PRODUCT BULLETIN

Publish Date: January 10, 2018
Effective Date: March 1, 2018
Subject: Product Change - Conduit/Drainage Opening Size
Products Affected: Plastibeton Cable Trench Models T2012 through T4016

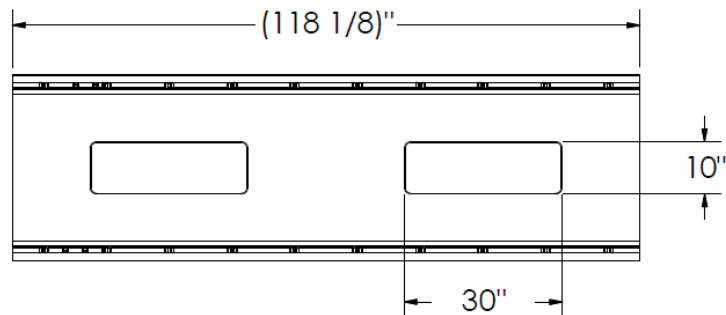
Description of the Change: In an effort to streamline product offerings and lead times and optimize product versatility, Oldcastle Enclosure Solutions (OES) is changing the standard conduit opening size.

Affected Models: T2012, T2016, T3012, T3016, T4016

Previous	New
Two (2) 10"x15" conduit/drainage openings	Two (2) 10"x30" conduit/drainage openings
